**AGENDA  
CITY OF CEDAR FALLS, IOWA  
PLANNING AND ZONING COMMISSION MEETING  
WEDNESDAY, AUGUST 14, 2019  
5:30 PM AT CEDAR FALLS CITY HALL**

**TO:** Planning & Zoning Commission  
**FROM:** Dennis Rutledge, Intern  
Iris Lehmann, AICP, Planner II  
**DATE:** August 8, 2019  
**SUBJECT:** College Hill Neighborhood Site Plan Review – 1809 College Street

TO: Planning and Zoning Commission
FROM: Iris Lehmann, AICP, Planner II
Matt Tolan, Civil Engineer II
DATE: August 8, 2019
SUBJECT: Prairie Winds 4th Addition Final Plat

TO: Planning & Zoning Commission
FROM: Iris Lehmann, ACIP, Planner II
Matt Tolan, Civil Engineer II
DATE: August 8, 2019
SUBJECT: Pheasant Hollow Seventh Addition Preliminary Plat

SITE PLAN  
LOT 14 AUDITOR RAINBOWS PLAT NO. 3  
PLANS: PB TINY HOUSE 4-19-19  
7-26-19

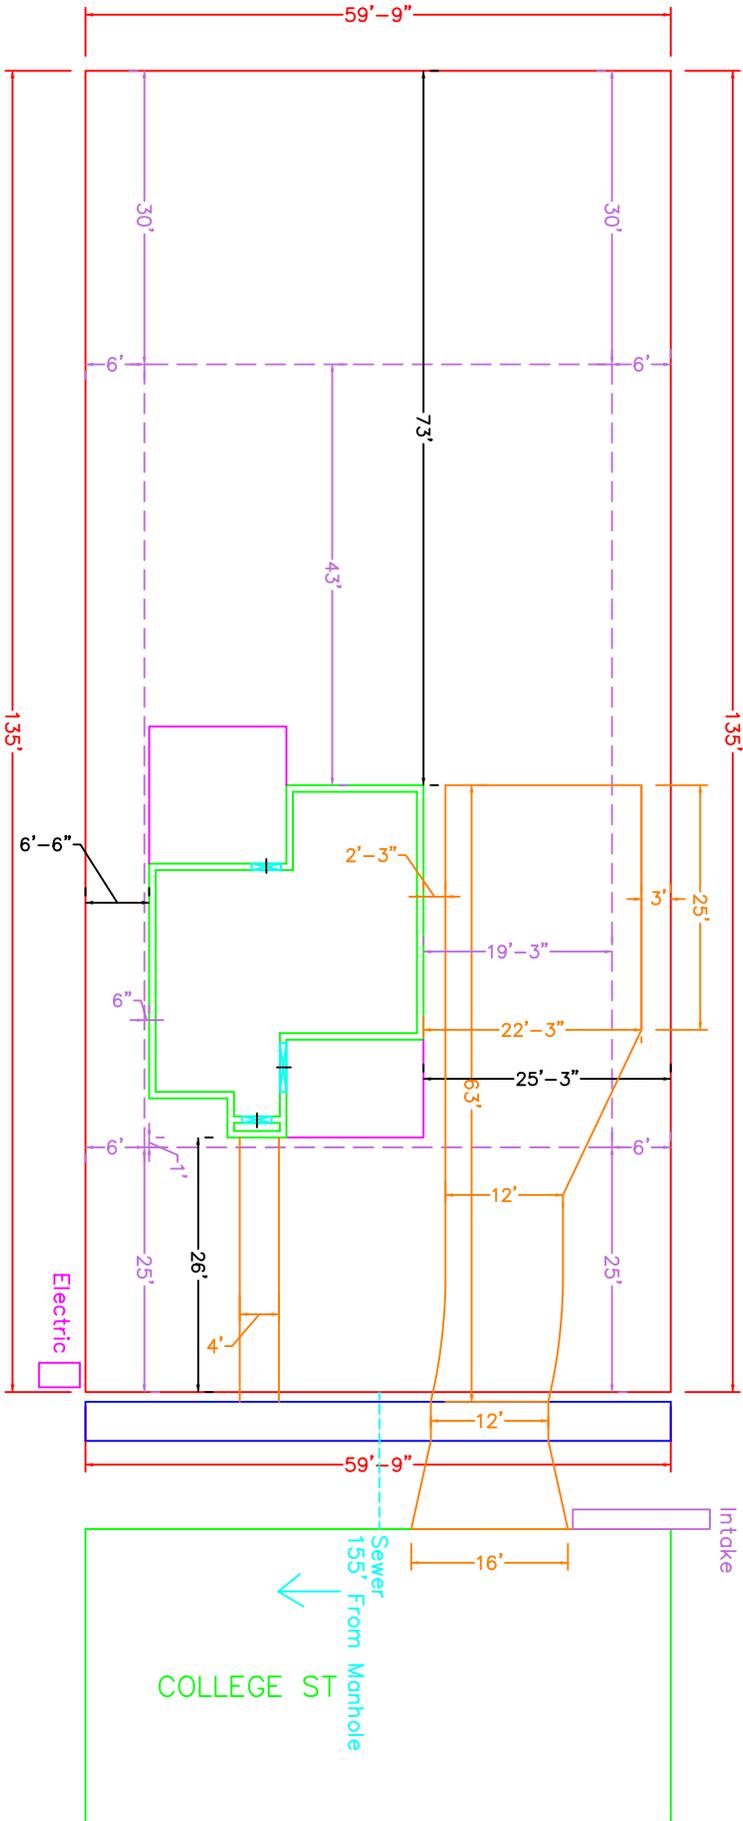
The property is zoned R-2, residential district. In this district the required lot width for a single unit home is 60 feet. The lot under consideration is 60 feet wide. The lot area required for a single unit home in the R-2 district is 7,200 square feet. The proposed property is 8,100 square feet. **The proposed lot area meets the R-2 District’s requirements.**

The required front yard setback in the R-2 district is 25 feet. The proposed front yard setback on this home is 26 feet. The required side yard setback in this district is 10% of the lot width. Since the width of this lot is 60 feet, a 6-foot setback is required. The side yard setbacks proposed are 6 feet 6 inches to the south and 25 feet 3 inches to the north; see image on the right. The rear yard setback requirement for the R-2 district is 30 feet. The

proposed single unit home has a rear yard setback of 73 feet. **The proposed building meets all setback requirements.**

The College Hill Neighborhood Overlay District requires single-unit dwellings to have two hard surfaced parking stalls per dwelling. The proposed concrete driveway is 12 feet wide and 63 feet long. The driveway also includes a flare out next to the home, widening the driveway to 22 feet and 3 inches. With this layout this property will have room for 3 parking spots; two in tandem in the driveway and one in the flare out. **The proposed parking meets the requirements.**

The College Hill Neighborhood Overlay District states that driveways measuring no more than 18 feet in width, sidewalks and pedestrian access ways measuring no more than six feet in width may be established across the required front and side yard areas. The driveway will have a 12 foot width. Other than the front and rear patio areas, the remainder of the lot will remain as open green space. **This meets all requirements.**

# PRELIMINARY PLAT PHEASANT HOLLOW SEVENTH ADDITION REPLAT OF TRACT "M", PHEASANT HOLLOW SIXTH ADDITION CEDAR FALLS, IOWA

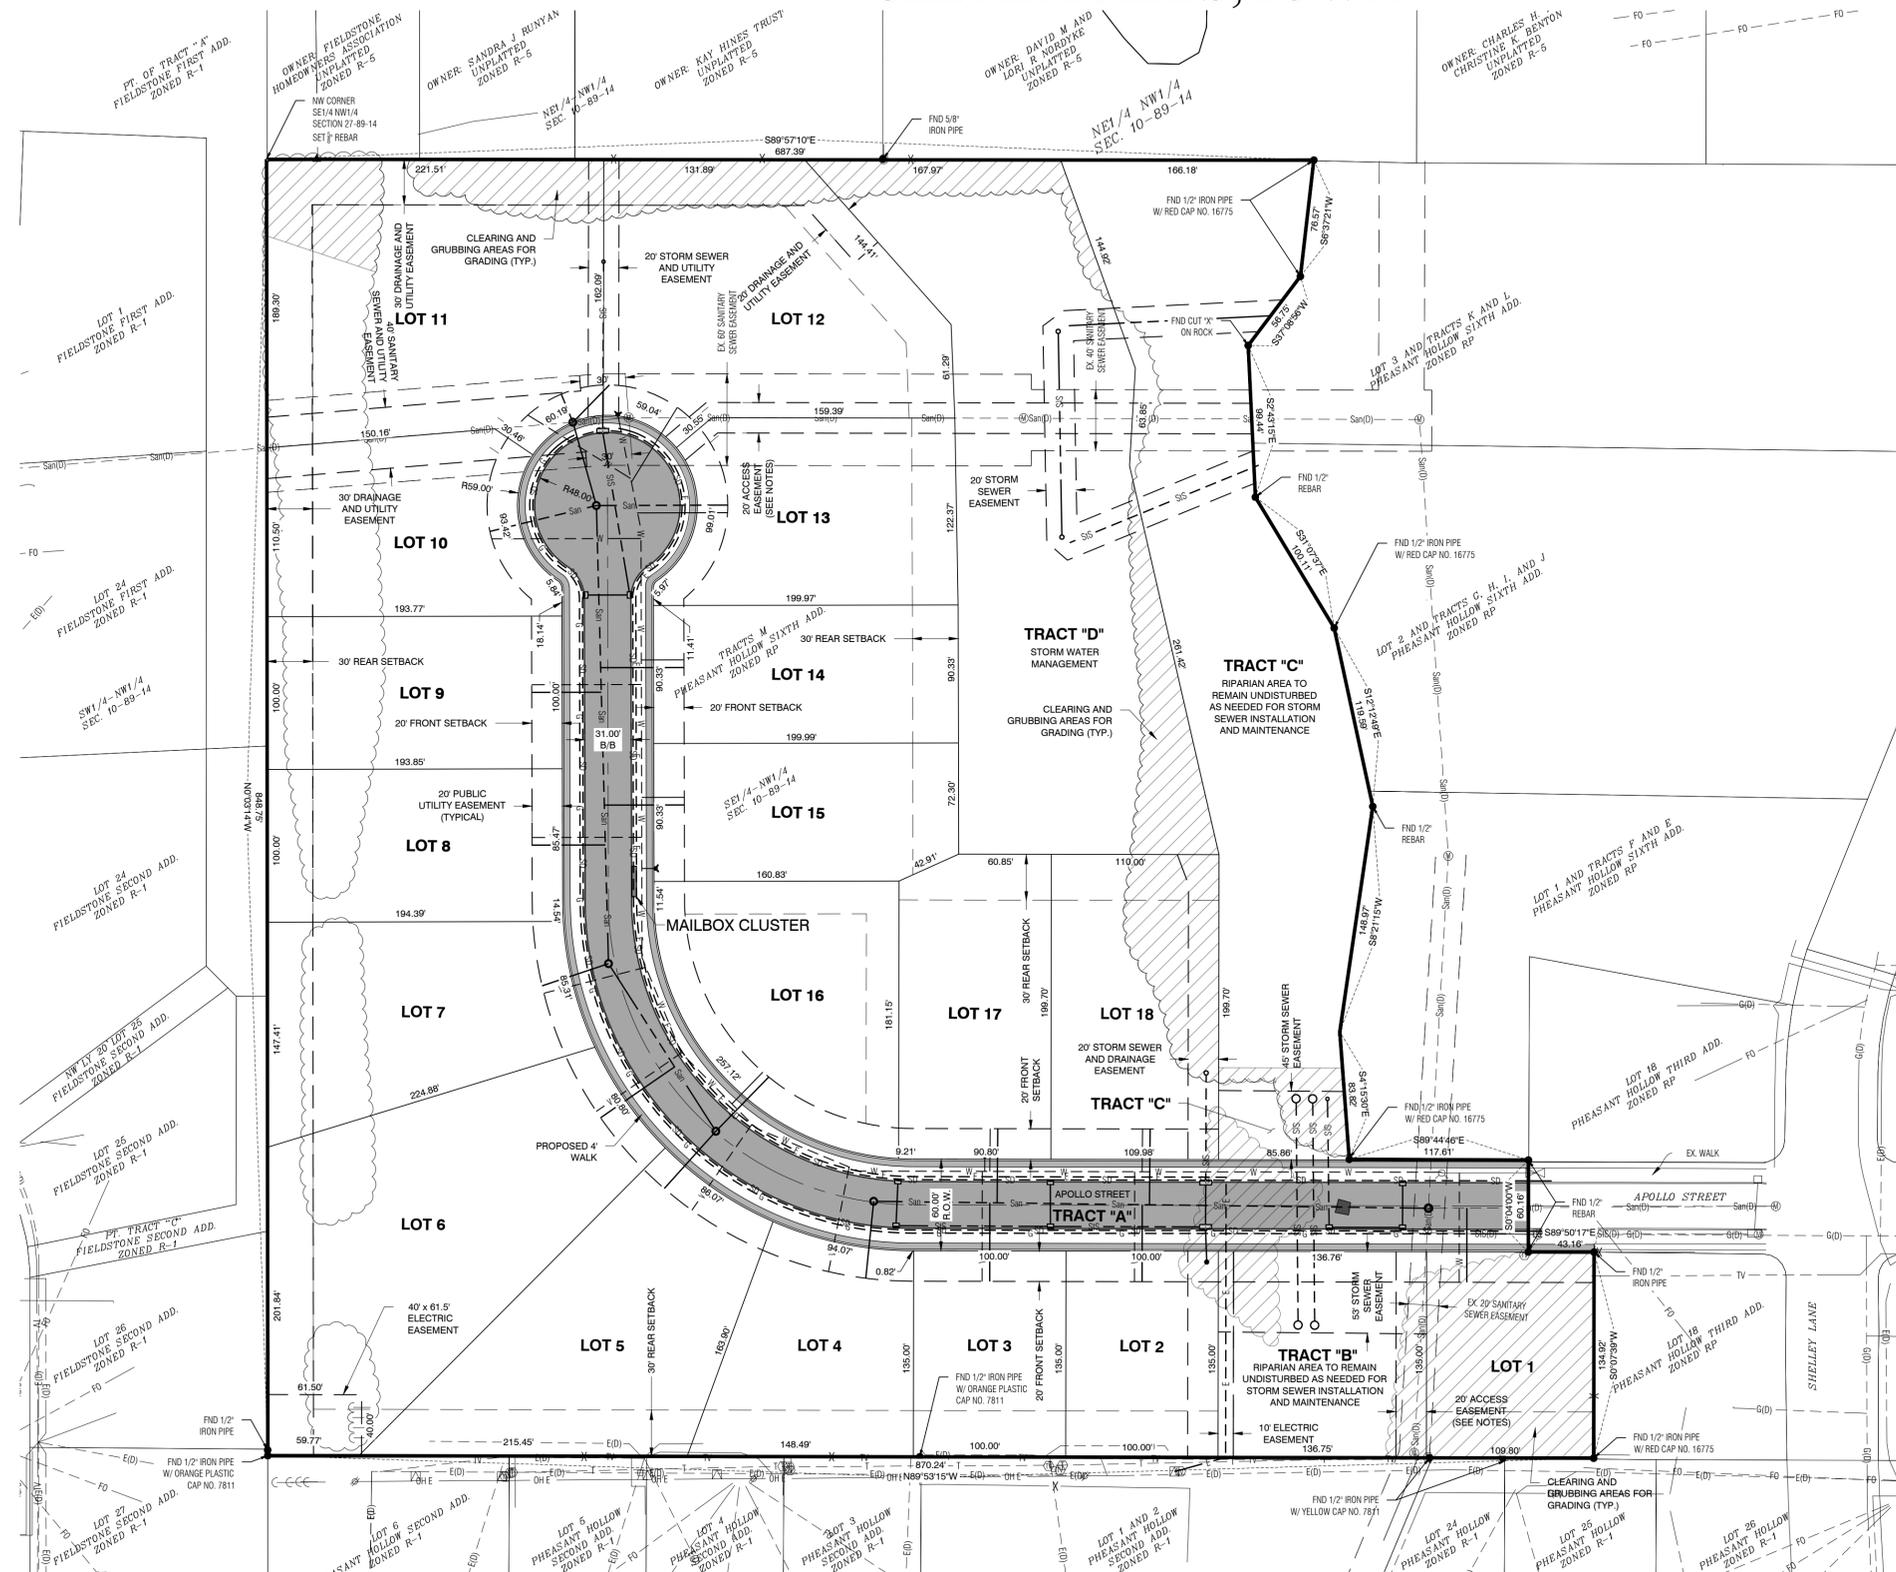
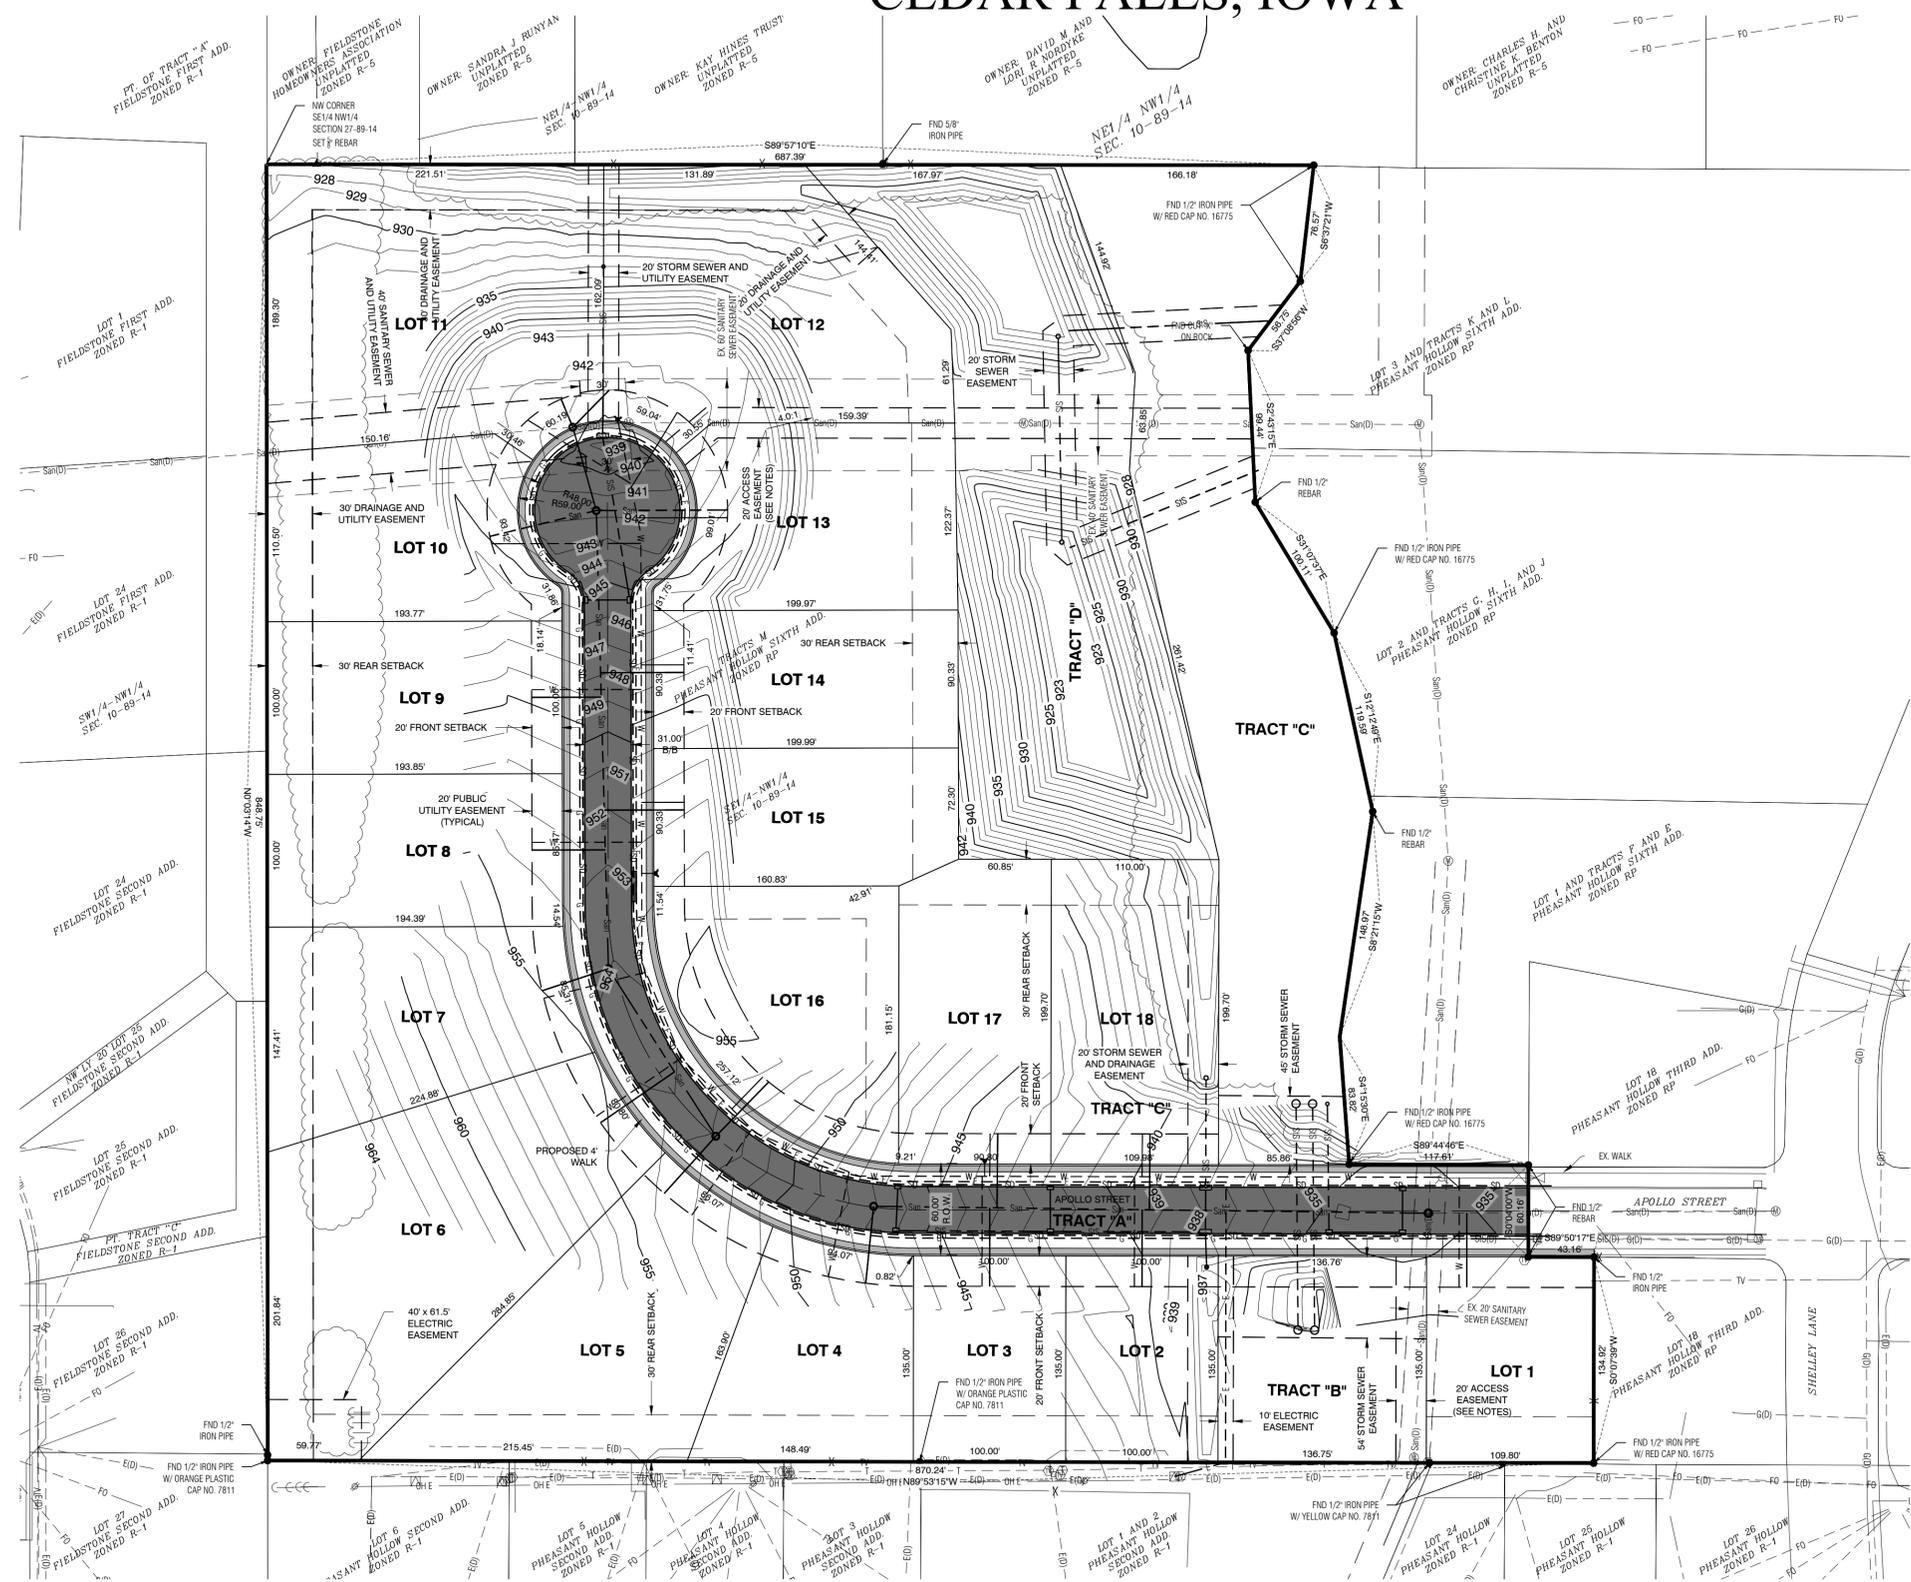
1. Details are needed on where the required cluster mailboxes will be placed.
2. Based on a comment received from a neighboring property owner to the south (see attached correspondence), an additional drainage swale may be needed along the

- 1) Any comments or direction specified by the Planning & Zoning Commission.
- 2) Details are submitted on where the required cluster mailboxes will be placed.
- 3) Topography and drainage pattern along the southern border of the plat will be reviewed and an additional drainage swale and associated drainage easement will be added to the plat, if necessary.
